TOYOTA SERVICE BULLETIN
Group: 06 No.: 05 Date: May, 17

Model: LandCruiser URJ202 & VDJ200

Subject: Corrections to Repair Manual RM22W1E

Section	Title	Paragraph
AXLE AND DIFFERENTIAL	REAR AXLE SHAFT	REASSEMBLY

[Corrected]

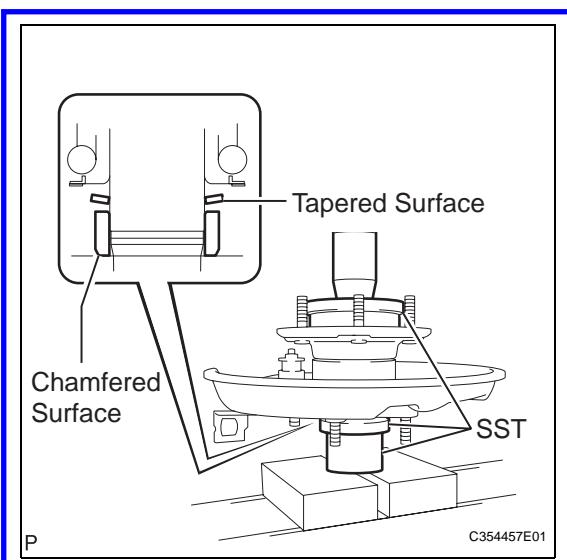
- (a) Install the washer and a new retainer to the axle hub as shown in the illustration.

- **Install the washer with its tapered surface facing downward.**
- **Install the retainer with its chamfered surface facing downward.**
